PARTS & SERVICE NEWS

REF NO.	AT02195
DATE	Jan. 15, 2003

SUBJECT: INTRODUCTION OF THE IMPROVED EXHAUST VALVE ON WA800/WA900

PURPOSE: To introduce the improved exhaust valve on WA800/WA900

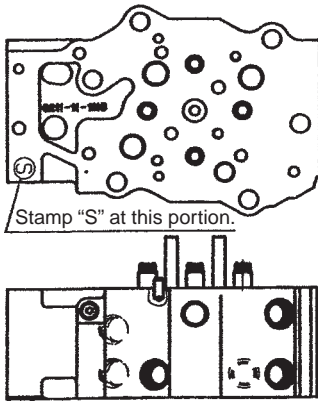
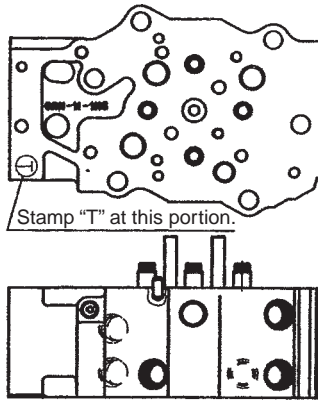
As for the above-mentioned engines, depending on the use, for the short margin of durability, the failure of exhaust valve cone (cone crack) may occur.

In this case, this is repaired by this service news.

(1) Change of exhaust valve seat

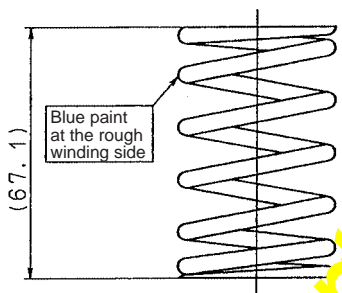
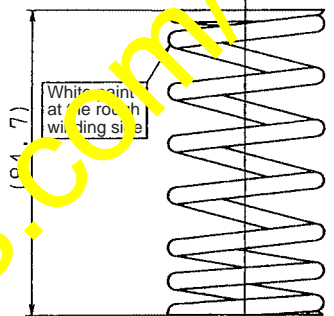
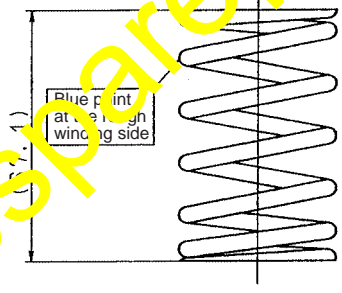
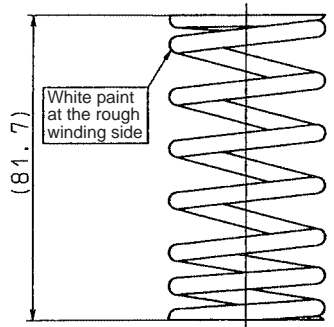
The material of exhaust valve seat is changed and the wearing of contact surface between the exhaust valve and the exhaust seat is improved. Therefore, the margin of durability for the exhaust valve is improved.

Part Name	New	Old
Cylinder head ass'y (The material of exhaust valve seat is changed.)	6215-11-1300 Identification stamp "S"  Stamp "S" at this portion.	6215-11-1100 Identification stamp "T"  Stamp "T" at this portion.
	Exhaust valve seat	6215-11-1320 Sintered material of iron group

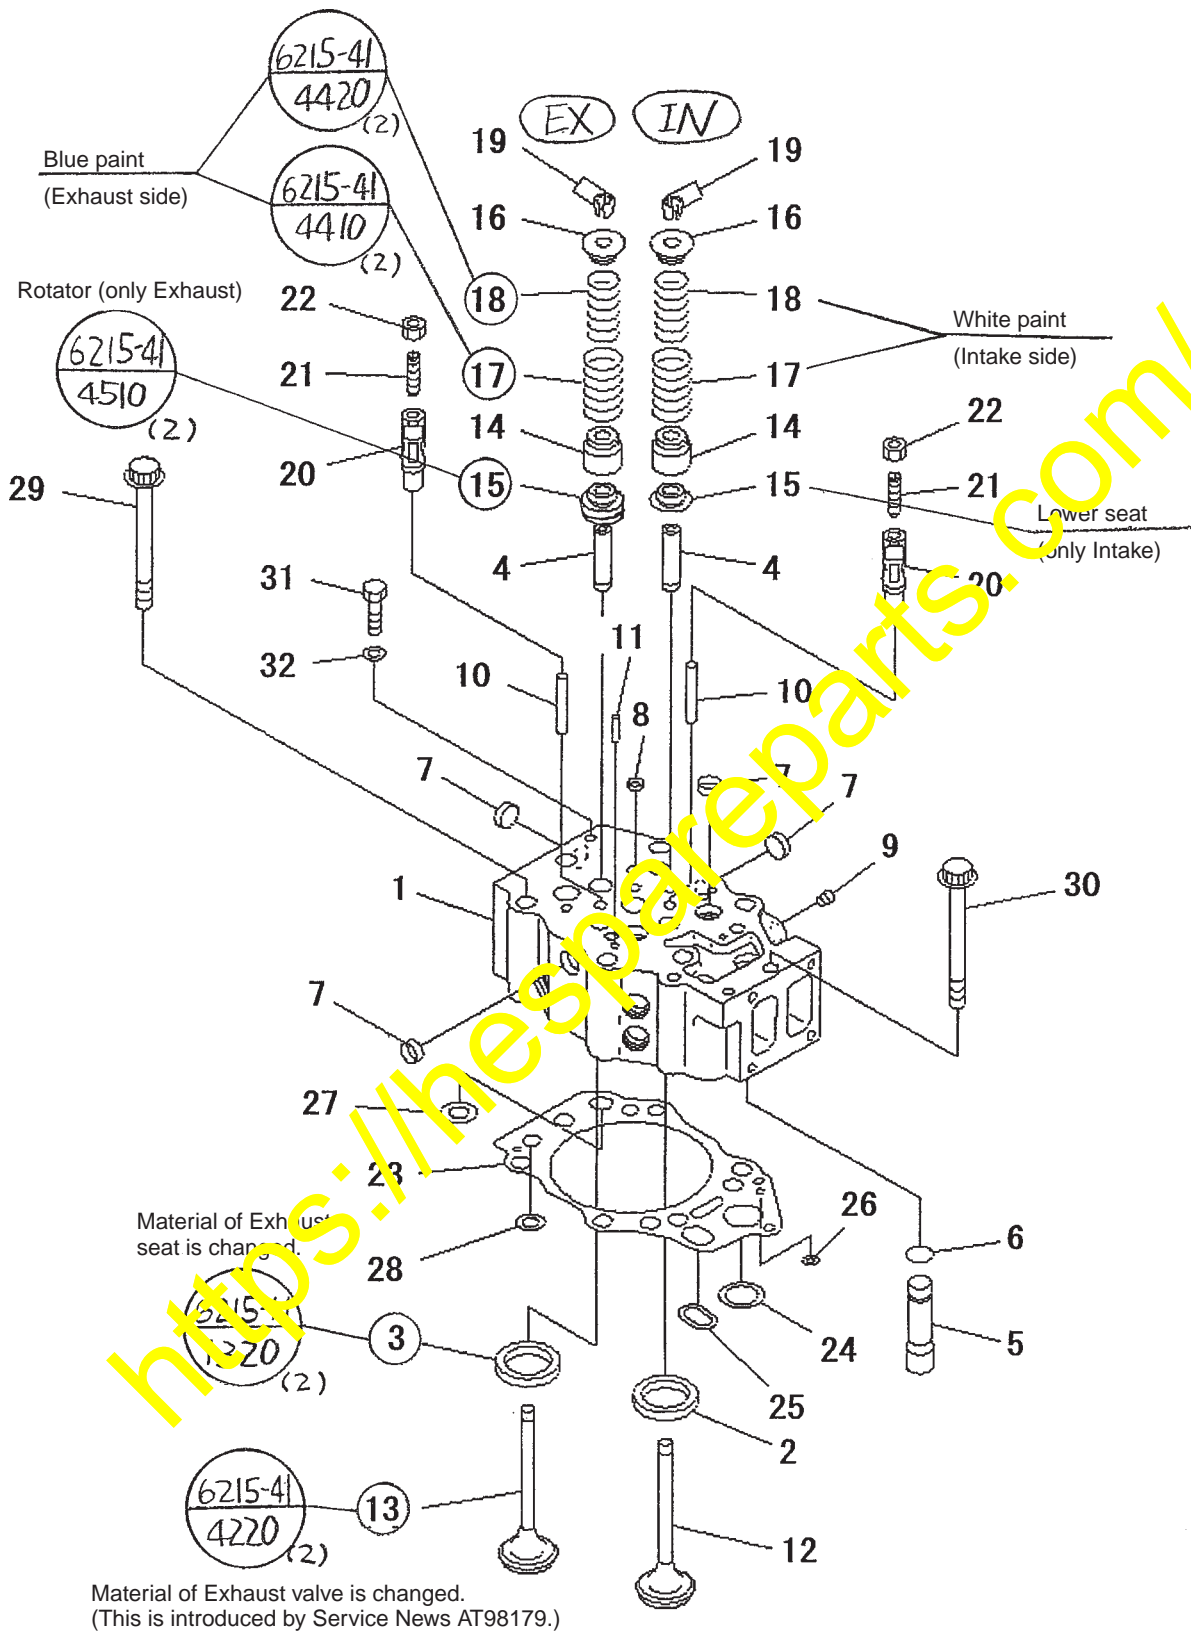
Note : Conventionally, the intake and the exhaust valve springs were commonly used. But, by this repair, they are not commonly used.

Because they differ in the longitudinal dimensions, if they are mistakenly used, the serious failures such as the valve dropout occur. In addition, as for the rotator and the lower seat, the thickness is different. For this reason, if the corresponding valve springs are not assembled, similarly the valve dropout occurs. Therefore, fully take care for the mis-assembling.

Parts enclosed by a circle are changed.
